Procurement Department Bid Section

ADDENDUM NUMBER: ONE (1)

TITLE: 1412066050 (RFP) Brandy Branch Generating Station Ammonia Injection Lance Upgrade and Ammonia Sampling Grid

Typical cold start-up data for Unit 2 & Unit 3:

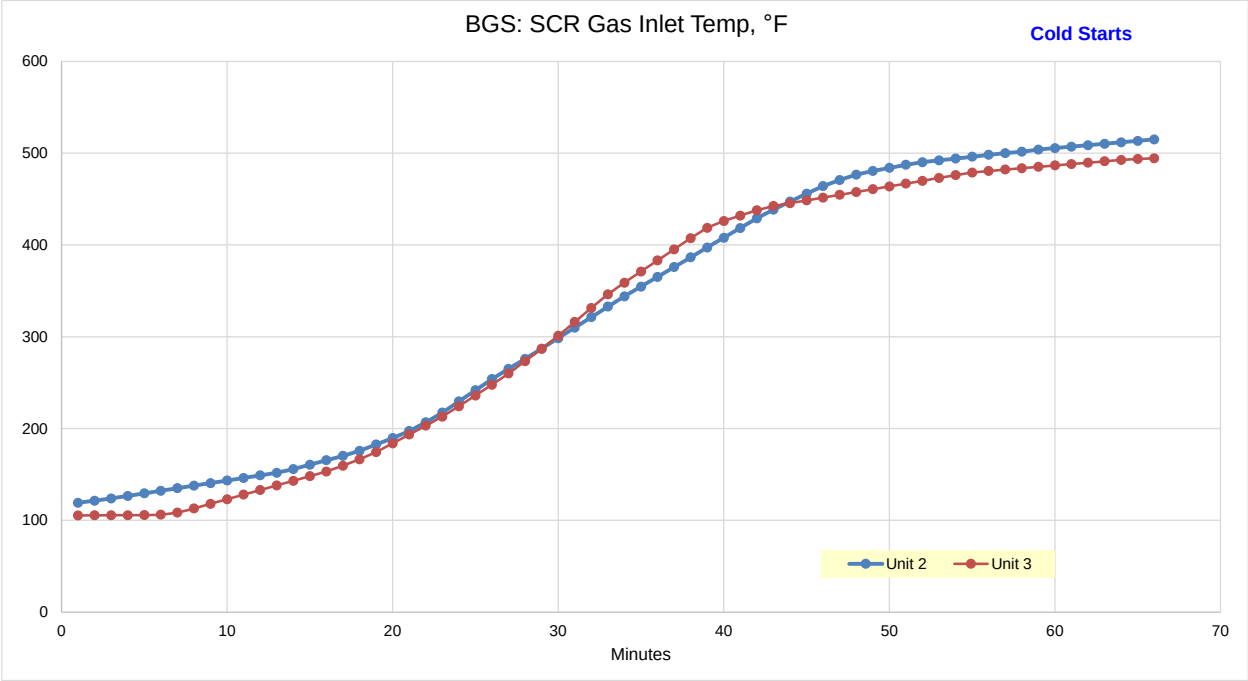
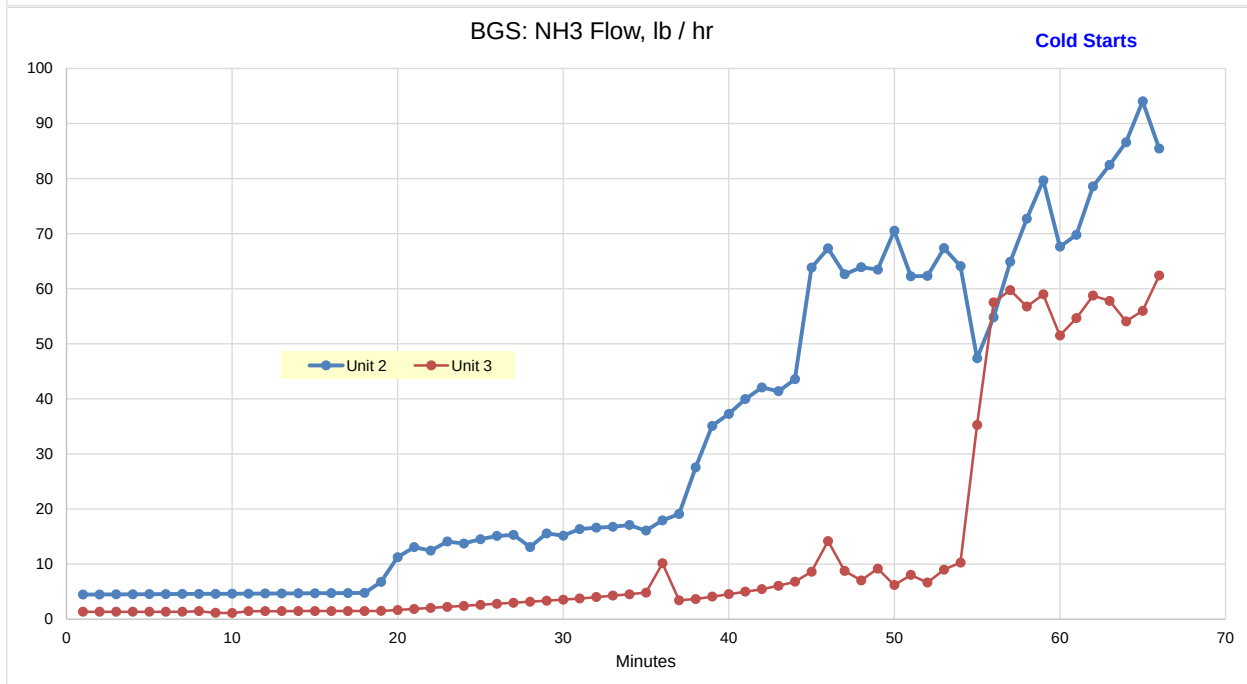
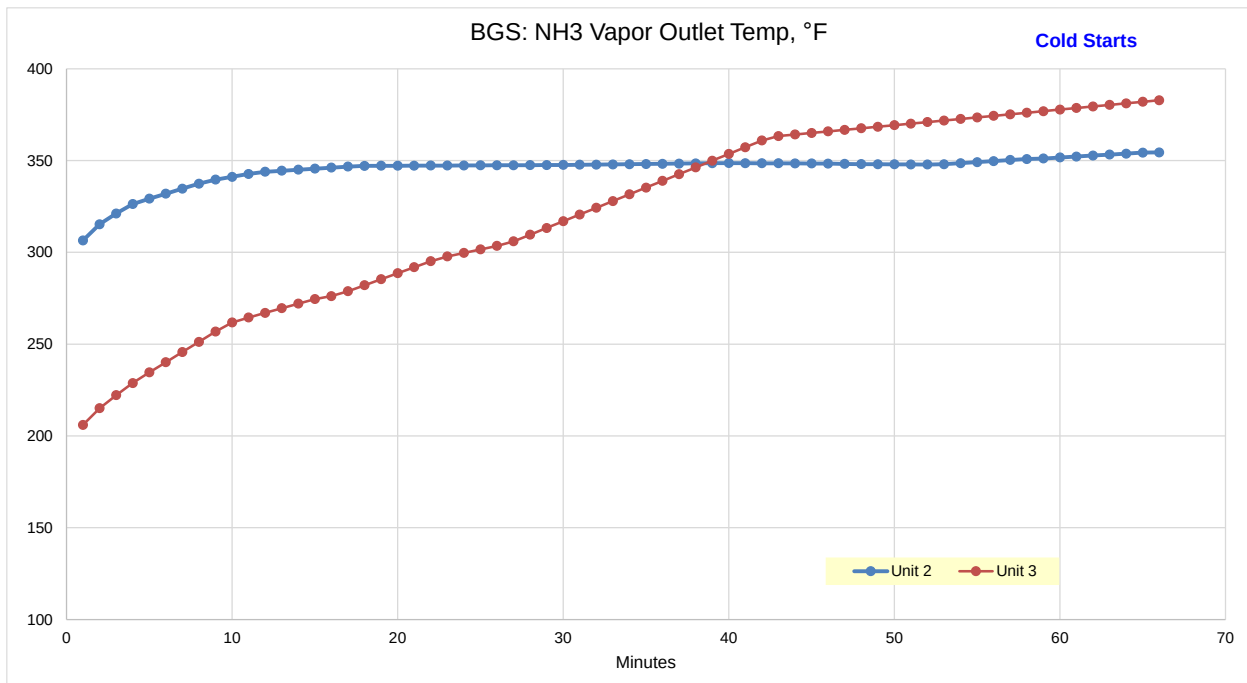
Question: It has been described to us that a part of the reason for seeking an upgrade to the AIG is due to plugging/fouling of the bottom injection holes in the AIG runners.

In advance of the forthcoming pre-bid TEAMS meeting, would it be possible to obtain a trend of the following data points, in that they may help bidders better understand the present system operations?

Over a typical cold start timeline:

- CT start
- CT Load
- AIG inlet temperature
- SCR (gas side) inlet temperature
- Ammonia injection start
- Ammonia injection flow rate ramp
- Full load, normal ammonia injection load

- Unit 2: 5 starts
- Unit 3: 4 starts
- All data shown starts 15 minutes before sync

Full load normal injection rate: 50 - 80 lb / hr
